LEXINGTON-FAYETTE URBAN COUNTY GOVERNMENT CONTRACT CHANGE ORDER Page 1 of 2	Date:	May 29, 2015	
	Project:	Stone Arch Repair	
	Location:	Dunbar Community Ctr	
To (Contractor): ABC Construction	Contract No.	97-2015	
	Original Contract Amt.	\$39,400.00	
	Cumulative Amount of Previous Change Orders	\$0.00	
	Percent Change - Previous Change Orders		0.00%
	Total Contract Amount Prior to this Change Order	\$39,400.00	
	Change Order No.	1

DUNBAR STONE ARCH REPAIR

Re: Request for Change Order #1 at Dunbar Community Center
Purchase Order #LF00124588

Sheet Number
S-1

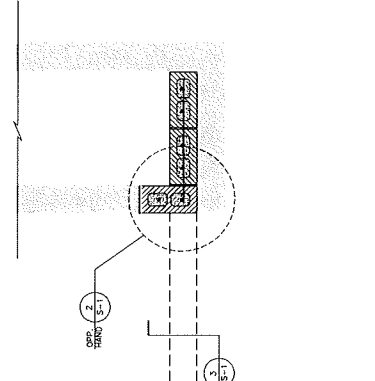
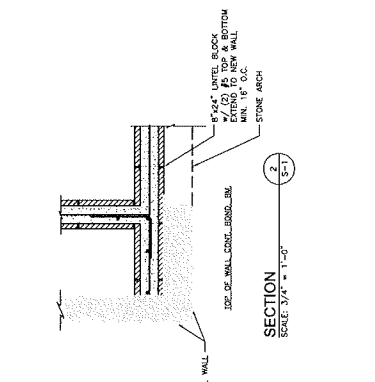
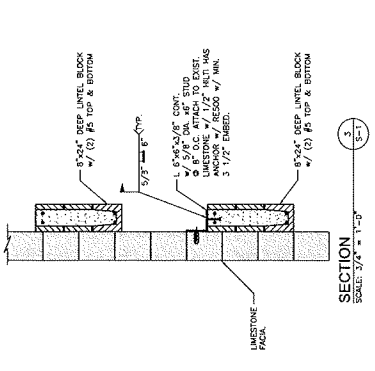
This change order is being submitted to correct concealed conditions discovered at the Dunbar Stone Archway Renovation. All work in this change order is based on the original plans and specifications of Fitzsimmons Office of Architecture and the drawings submitted by Pyramid Consulting Structural / Civil Engineers Sheet S-1.

This Change Order will be for installing two new footers at the inside base of the wall, building a new wall from these footers close to the full height of the wall. It will also raise the two existing block walls upward near the roof of the structure. These walls will be reinforced with concrete and steel as specified. A new angle iron will be installed behind and above the stone arch with epoxy anchors tying the new wall and stone together. This work will require the existing ceiling to be removed and replaced.

General view during construction. 5/8/15

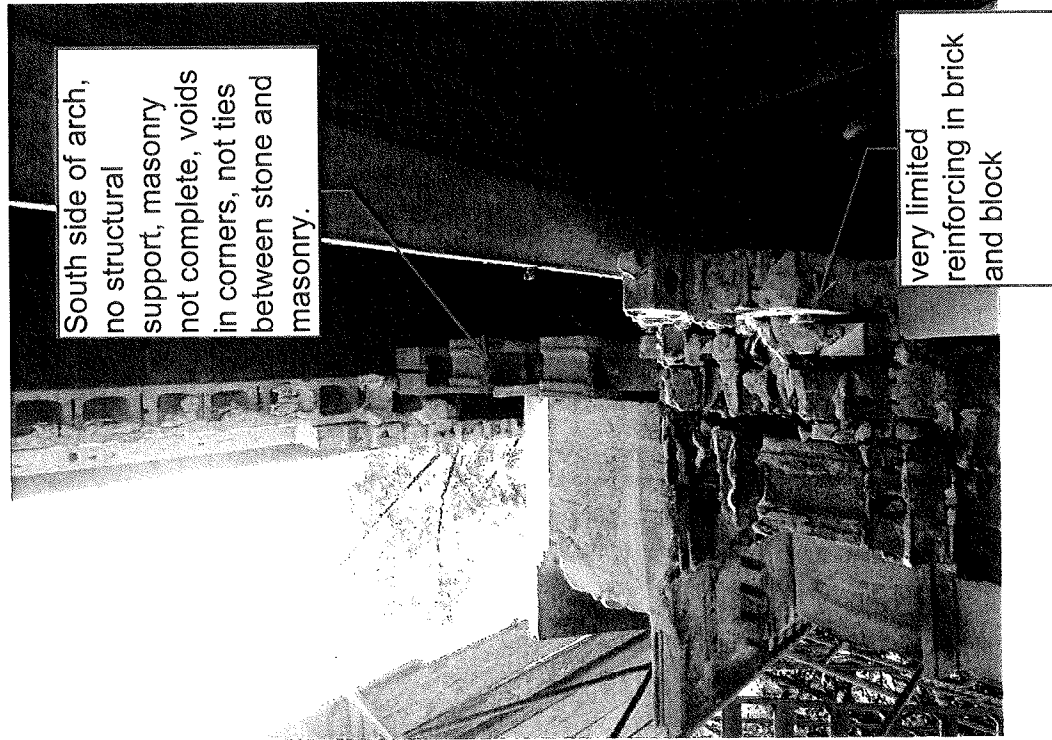
South side of arch,
no structural
support, masonry
not complete, voids
in corners, not ties
between stone and
masonry.

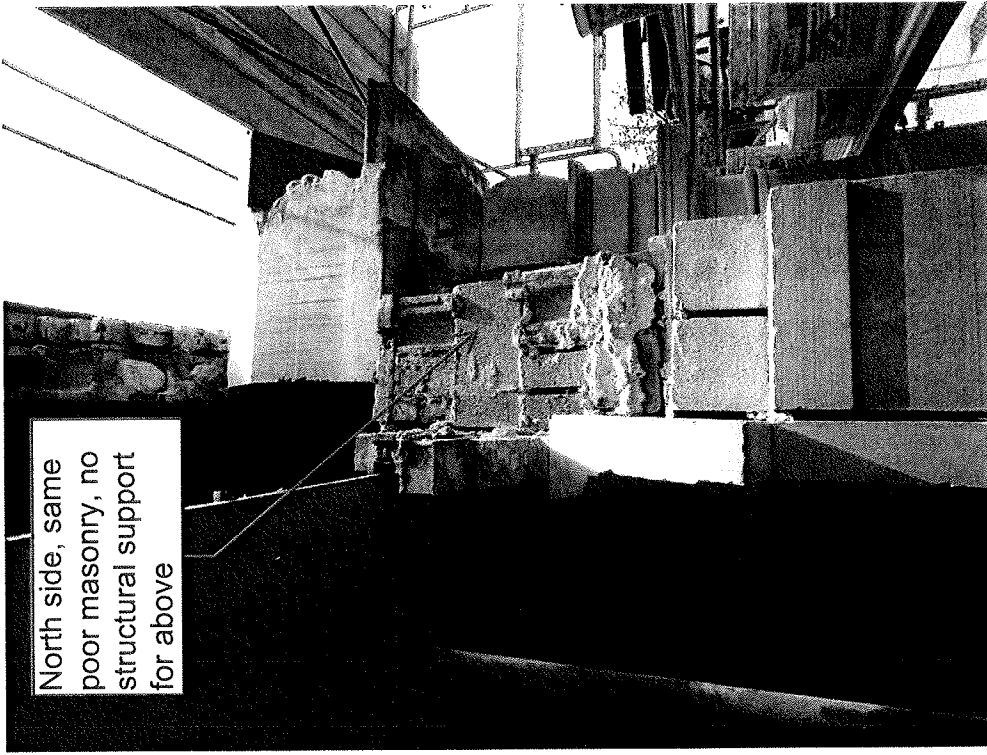
very limited
reinforcing in brick
and block

North side, same
poor masonry, no
structural support
for above

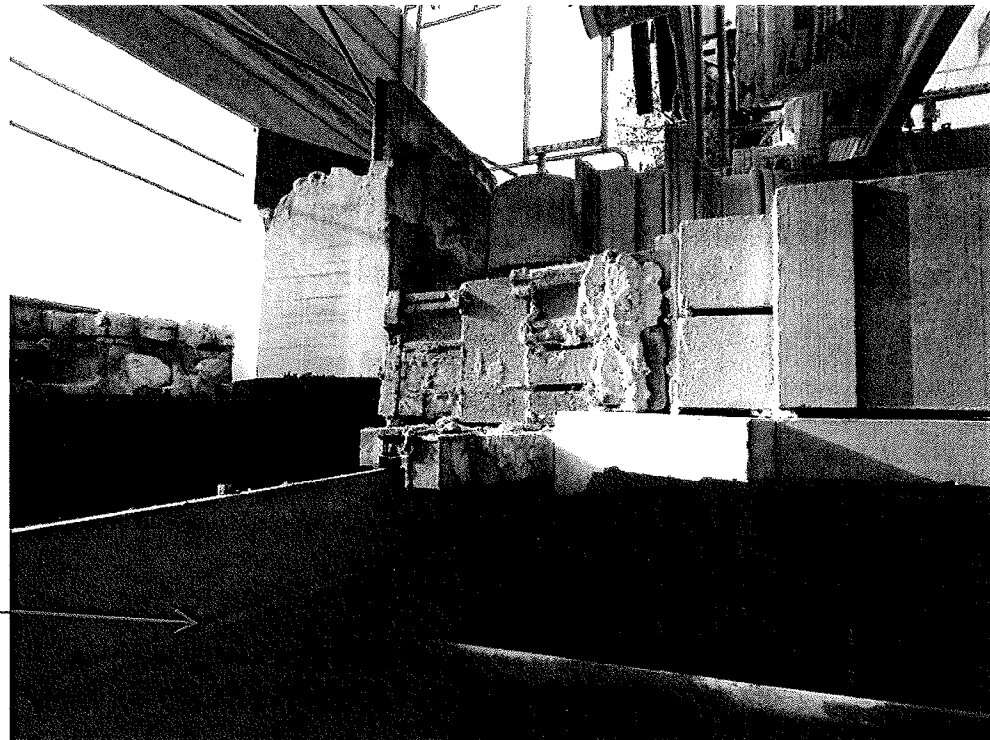
plaster ceiling
suspended from
above

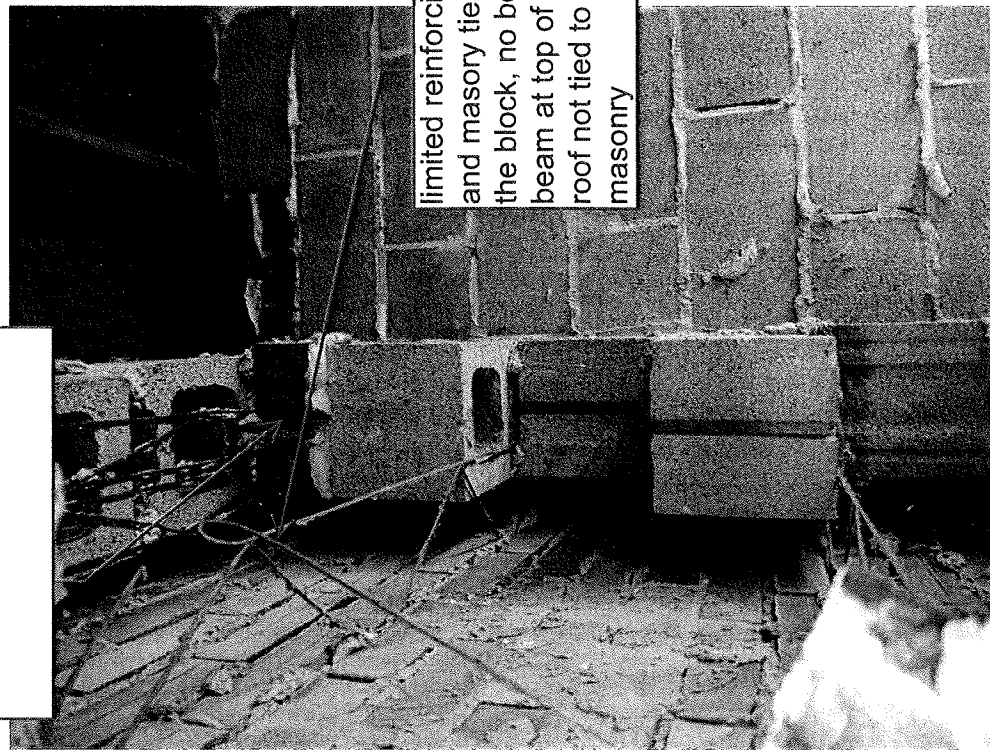
poor quality masonry infill,
not complete backup wall,
voids in the block

limited reinforcing
and masonry ties to
the block, no bond
beam at top of wall,
roof not tied to
masonry
